RE: Take 5 – 1990 S Havana Street Auora, CO - Building Conversion – Site Plan Resubmittal #1

Please find our comment response table attached regarding the City of Aurora DA-1458-26 resubmittal #1 for the proposed Take Five Oil Change at 1990 S Havana Street in Aurora, CO.

Comment Reponse

SITE PLAN
TAKE 5 OIL CHANGE
1990 S HAVANA ST LLC
1990 S HAVANA ST, AURORA, CO 80014
SITE PLAN APPLICATION

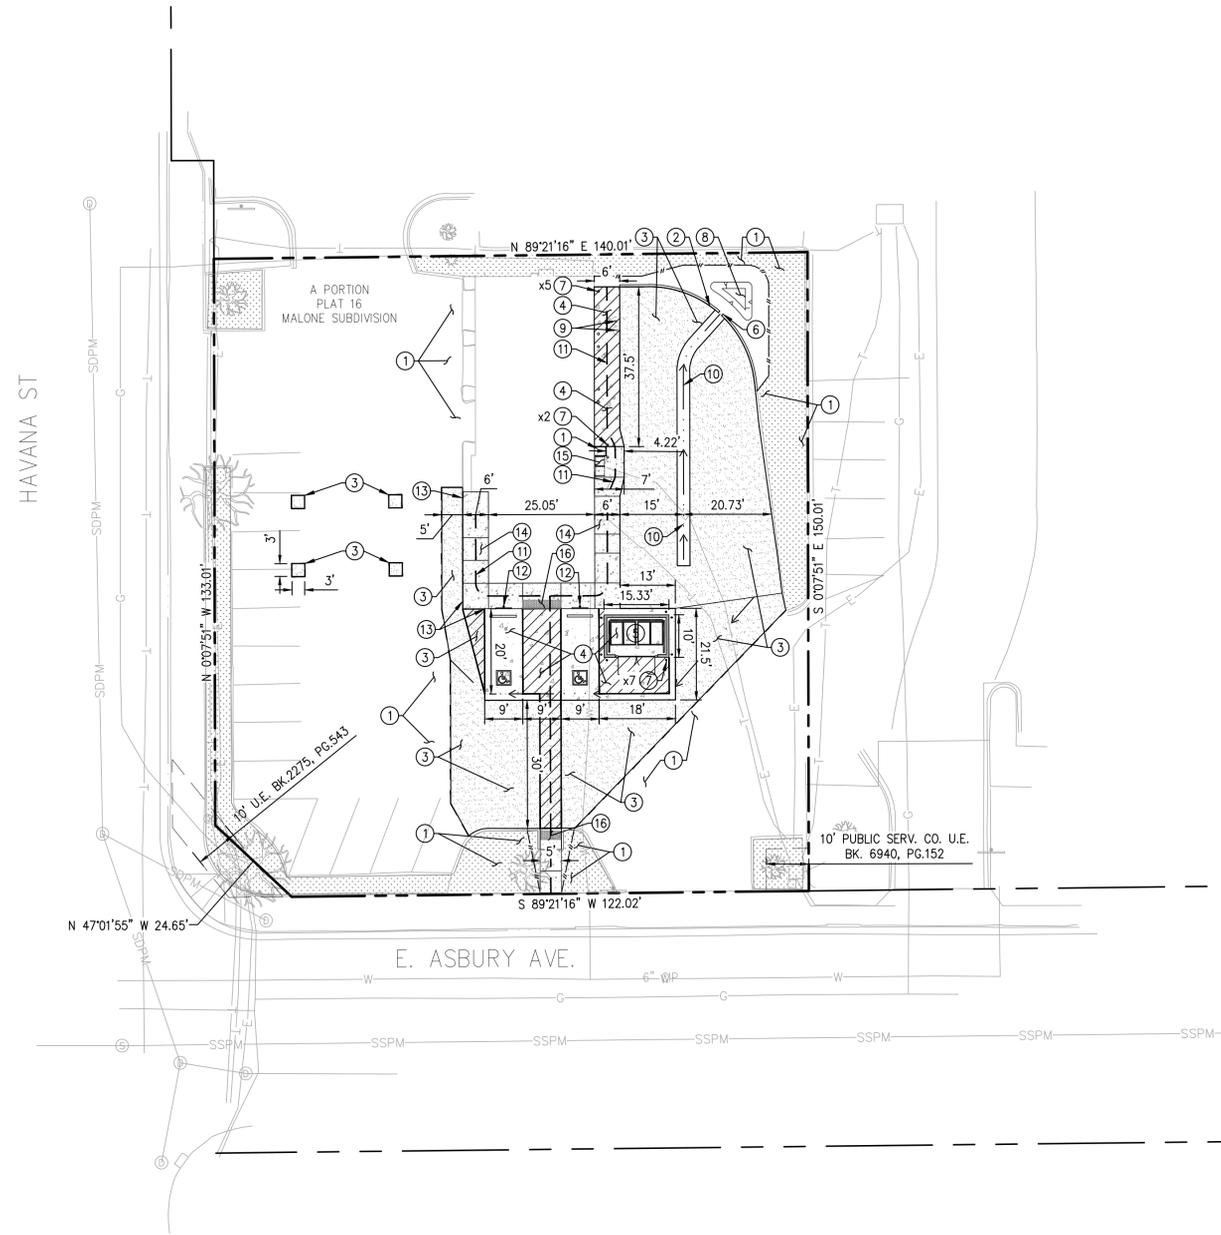
11. Traffic Engineering				
11A	See redline: Show or add a note that there will be no vehicle access from Havana Street.	3	<input checked="" type="checkbox"/>	The existing driveway is requested to remain at this location. The traffic memo prepared supports this driveway to remain with the change in use and CDOT has requested use to submit an access permit.

REFUSE ENCLOSURE
TAKE 5 OIL CHANGE
1990 S HAVANA ST LLC
1990 S HAVANA ST, AURORA, CO 80014
SITE PLAN APPLICATION

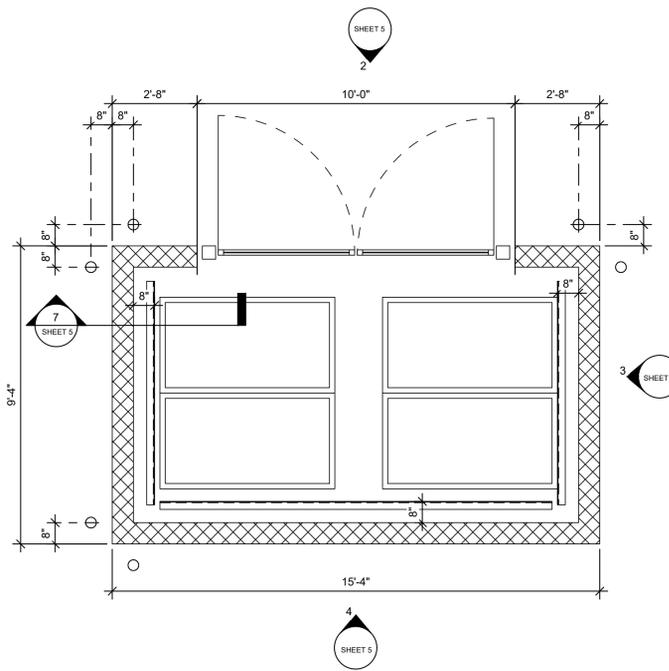
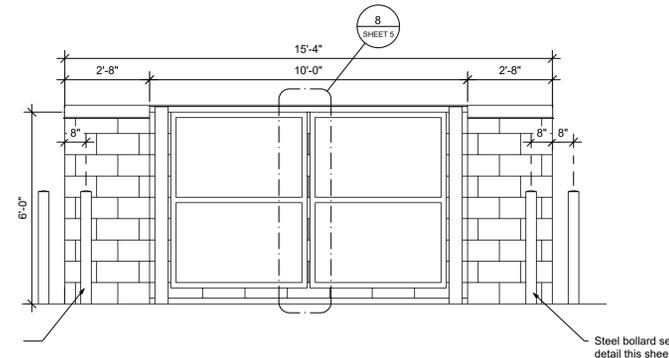
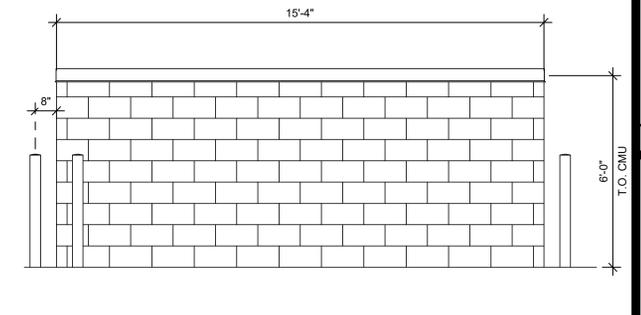
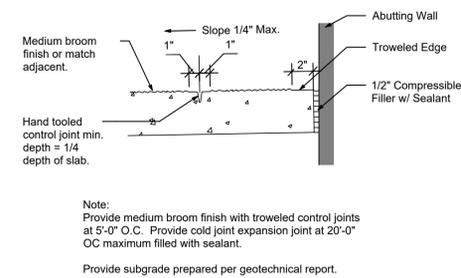
3. Zoning and Subdivision Use Comments				
3A	Trash Enclosure: Code Section 146-4.7.8.B.2.b requires that trash enclosures 'shall be screened on three sides by a minimum six-foot high masonry wall or an opaque fence enclosed on the exterior by evergreen plantings.' Please revise the plans to include exterior evergreen plantings around the exterior of the proposed trash enclosure. In addition, please clarify the proposed fence material for the trash enclosure. Is the proposed fence wood or metal?	3 & 5	<input checked="" type="checkbox"/>	The trash enclosure has been revised to a masonry wall structure.

BUILDING ELEVATIONS
TAKE 5 OIL CHANGE
1990 S HAVANA ST LLC
1990 S HAVANA ST, AURORA, CO 80014
SITE PLAN APPLICATION

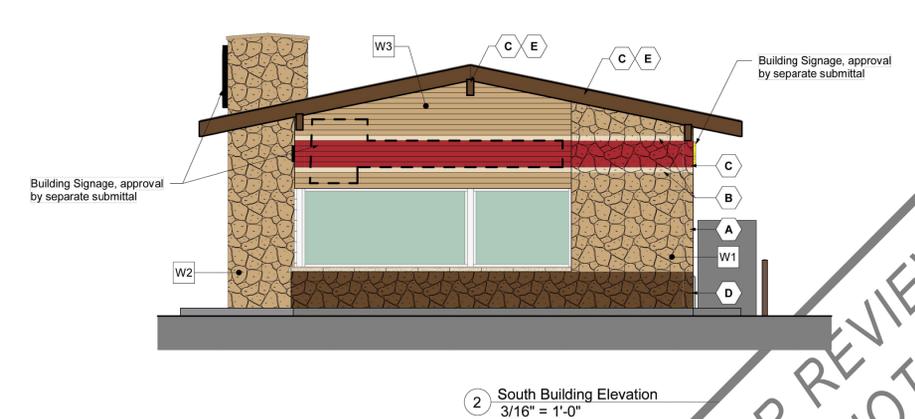
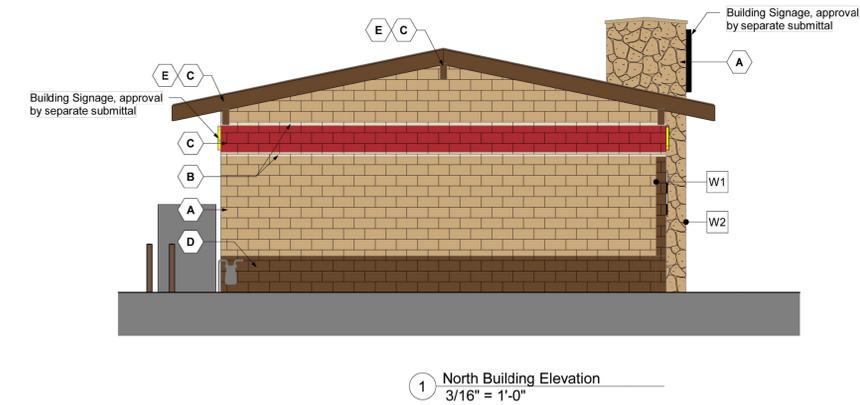
6D	Please add the same windows on the garage doors to the West building elevation to match the garage doors on the East building elevation.	7	<input checked="" type="checkbox"/>	Overhead doors have been updated.
6E	Recommendation: At the main entrance on the West facade, please include a patio area with seating for customers. Please update the Site Plan to include the patio area and proposed seating for the patio area.	7	<input checked="" type="checkbox"/>	This Facility is a drive through service where customers will not exit their vehicle. It is not anticipated that customers will enter the facility or exit their vehicles.

SITE PHOTOMETRIC PLAN
TAKE 5 OIL CHANGE
1990 S HAVANA ST. LLC
1990 S HAVANA ST. AURORA, CO 80014
SITE PLAN APPLICATION

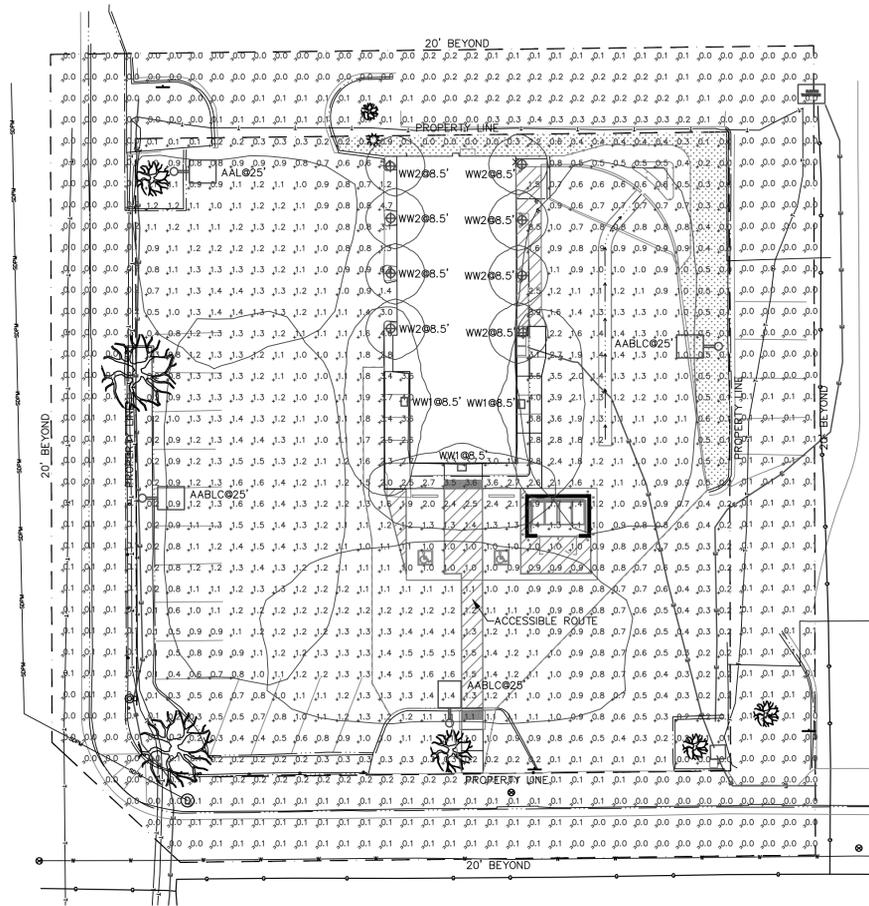
10F	See redline: Provide a hatch for this area. Cannot tell if this is a paved or landscaped area	3	<input checked="" type="checkbox"/>	Area is existing landscaping, clarification added to the plans.
10G	Provide an ADA path from the ROW to the building. Infrastructure along ADA path such as curb ramps, landing areas, etc. shall conform to ADA	3	<input checked="" type="checkbox"/>	ADA compliant parking, routes, signage and striping added to the plans
10H	Provide pavement sections in civil plans, not site plan.	4	<input checked="" type="checkbox"/>	Pavement sections removed from Site Plan.
10I	See redline: Do not provide City details. Only refer to City details via note.	4	<input checked="" type="checkbox"/>	City standard details removed from Site Plan.
10J	Provide photometric analysis for the ADA path. See comment on site plan sheet regarding ADA path.	8	<input checked="" type="checkbox"/>	Updated photometric analysis has been provided.
